**CAMECO RESOURCES
CROW BUTTE OPERATION**

Request for Additional Information for Response to License Condition 11.11
Crow Butte Resources, Inc., Crawford, Nebraska
Source Materials License SUA-1534
TAC No: L00762

Tank Vent Locations and Piping
Revised Figure

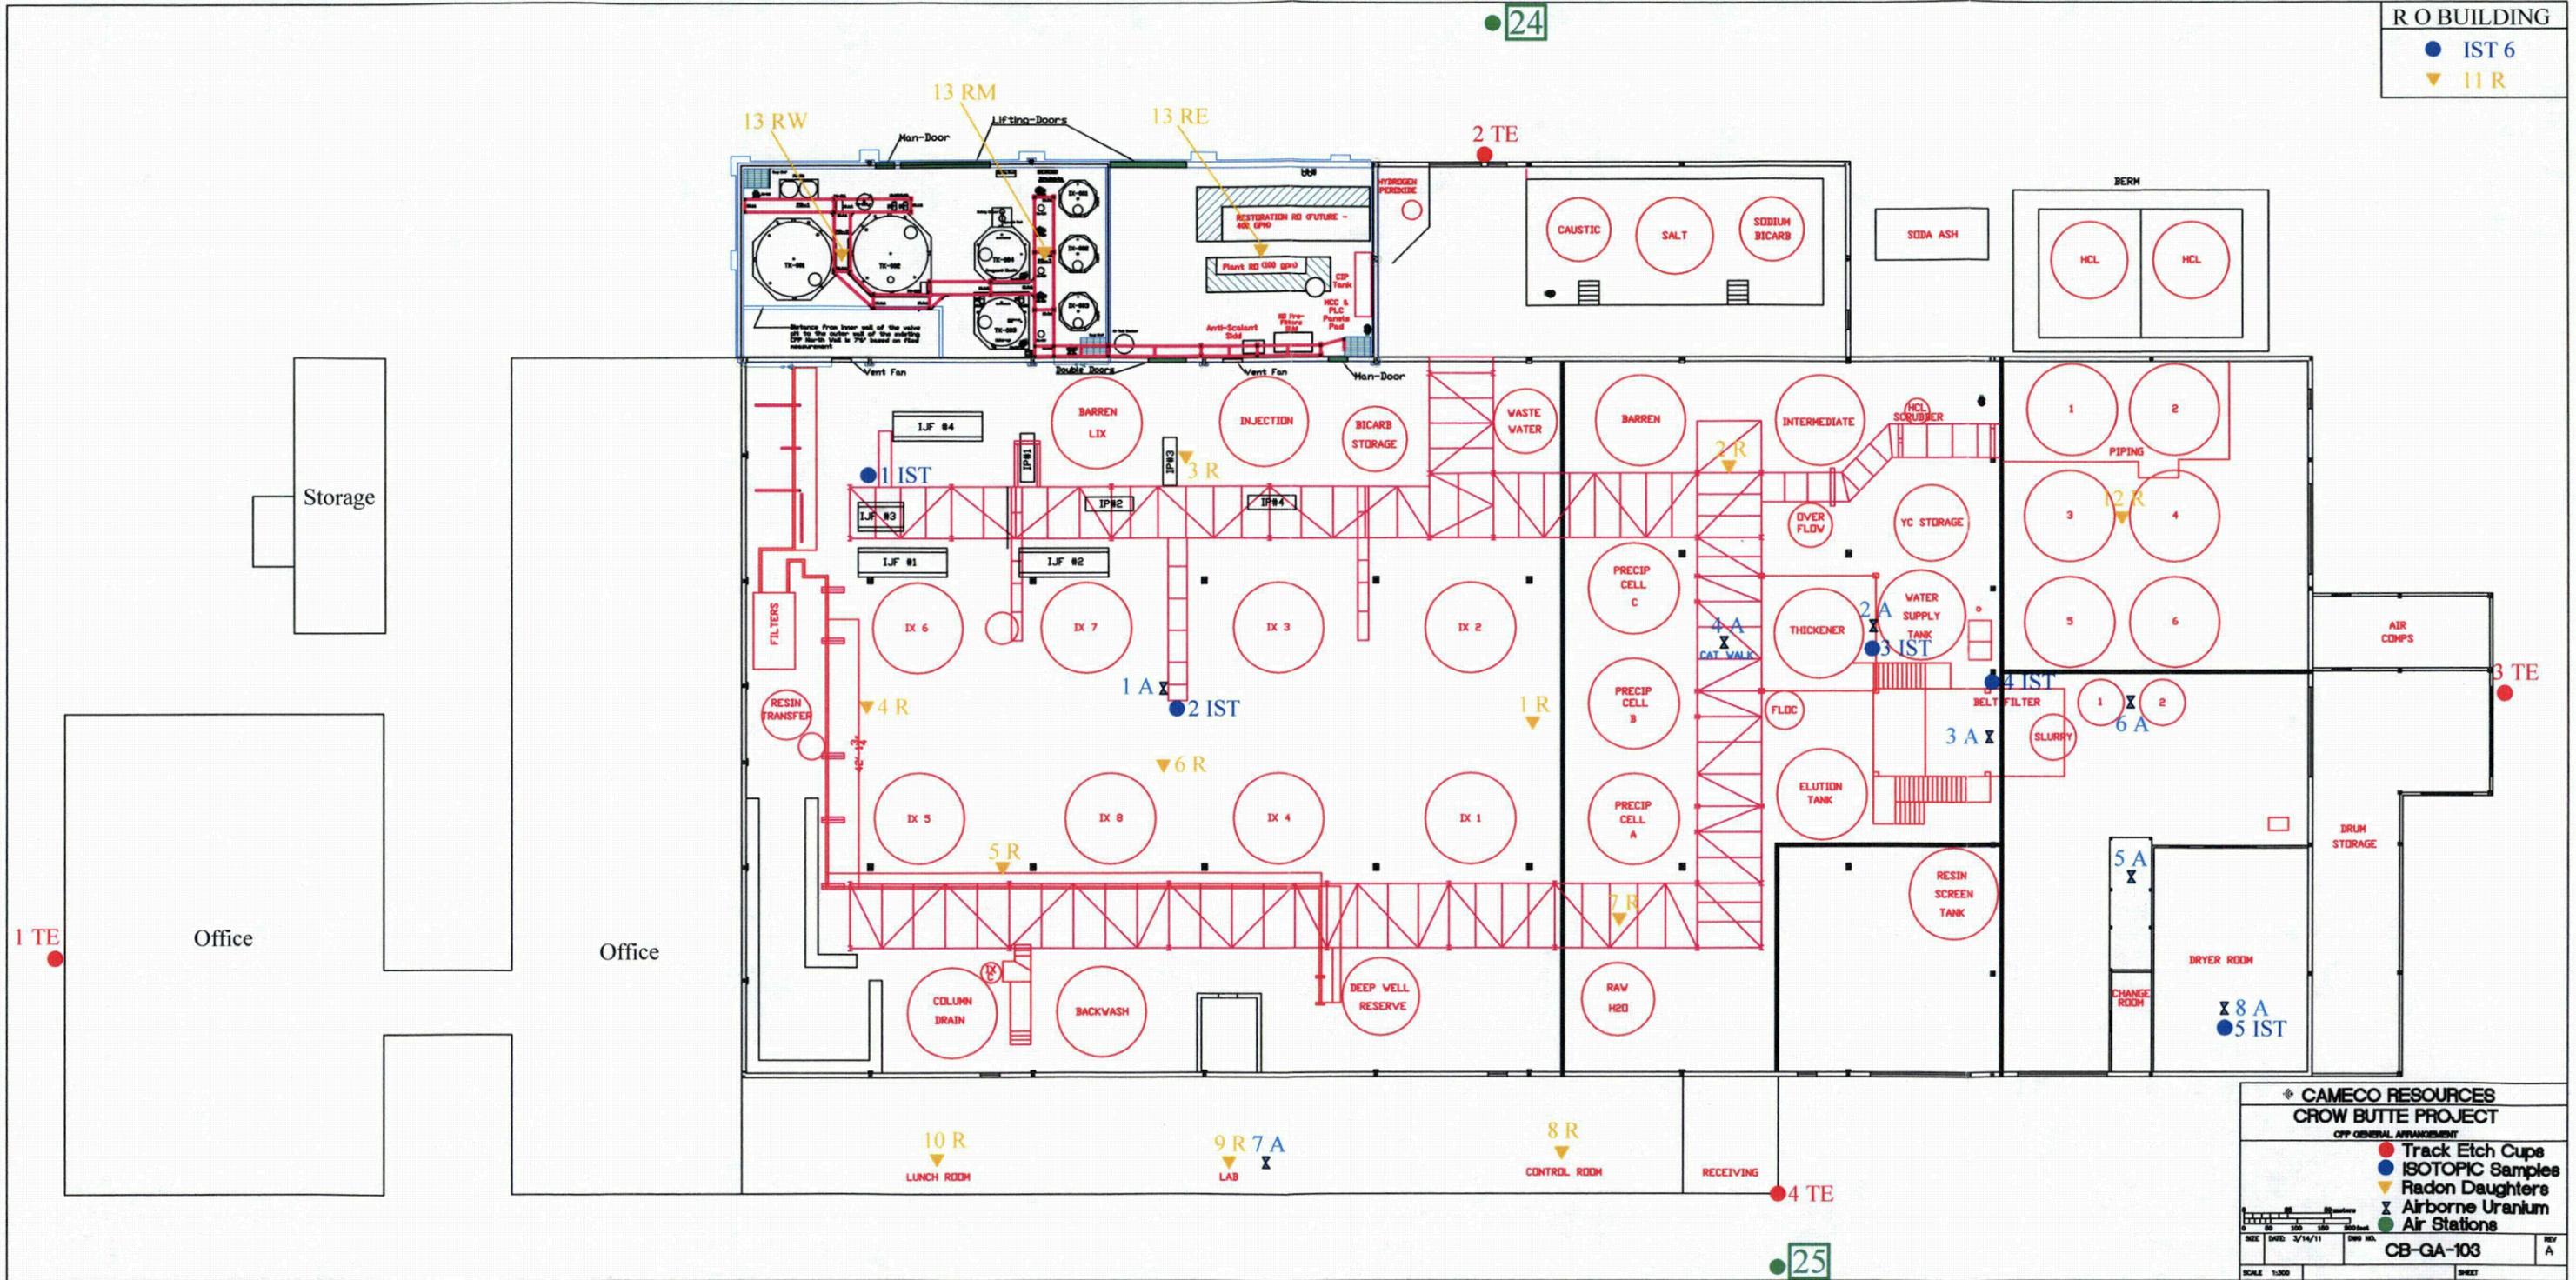
- B. Please provide a drawing that details current tank vent connections so that staff can verify the tank vent locations shown in the drawing "Tank Vent Locations" attached to Cameco's January 2, 2015, submittal.

The NRC staff observes that the licensee's response to this request included a drawing titled "Tank Vent Locations" that included the configuration of various tank vent intakes and ductwork as well as floor exhausts vent fans. As a separate action, the licensee also submitted a detailed study of the ventilation system at the Crow Butte facility in accordance with LC 11.14 (Cameco, 2014).

The NRC staff reviewed the licensee's responses to NRC staff's Request for Additional Information (Cameco, 2015a) and LC 11.14 (Cameco, 2014), the "Ventilation Report", together in order to understand the proposed methodology for measuring effluents at the Crow Butte facility. There appears to be inconsistencies between the RAI response (Cameco, 2015a) and the Ventilation Report (Cameco, 2014). For example, on the RAI response Figure Tank Vent Locations (Cameco, 2015a), there appears to be nine tank vent sample locations and three floor exhaust fans that discharge to the outside of the facility. On the other hand, Tables 4 and 5 of the Ventilation Report (Cameco, 2014) indicate a total of 10 tank vents, 3 box fans, 2 pipes, 1 room, and 1 unidentified duct that discharge to the outside of the facility.

Please provide clarify the relationship between the identified discharge points in RAI response Figure Tank Vent Locations (Cameco, 2015a) and the discharge points specified in Tables 4 and 5 of the Ventilation Report (Cameco, 2014). The purpose of this clarification request is to understand locations where effluents are being directed from the Crow Butte facility, in order to evaluate the licensee' effluent monitoring plan.

Included is a drawing showing the tank vent connections; based on this drawing, CBO has added an additional sampling point to account for resin cleaning.

Included is a drawing showing the tank vent connections, box fan, and exhaust pipe locations and are labeled as described in Tables 4 and 5 of the Ventilation Report (Cameco, 2014).

All tank vent locations (10) will be assessed as described in Crow Butte's response to RAI 1A.
